Notice of Allowability

10/808,635

TEO, SIEW SIONG

FIGURE 6

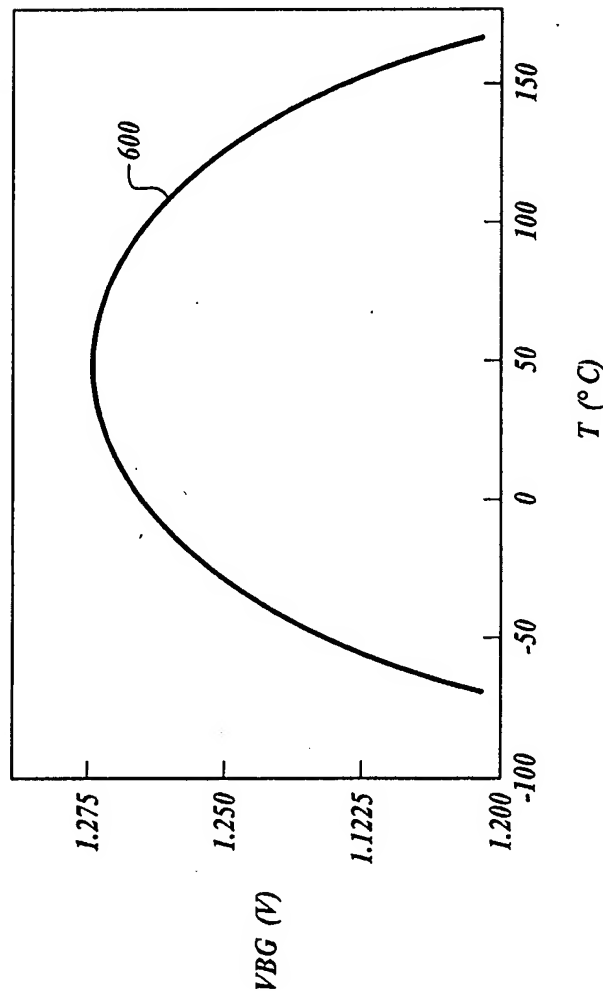
The Replacement Sheet for Fig. 6, and the amended paragraphs, and/or associated comments, overcame the objections to Figs. 5-6 as described on pages 2-3 of the previous Office Action. Therefore, those objections have been withdrawn.
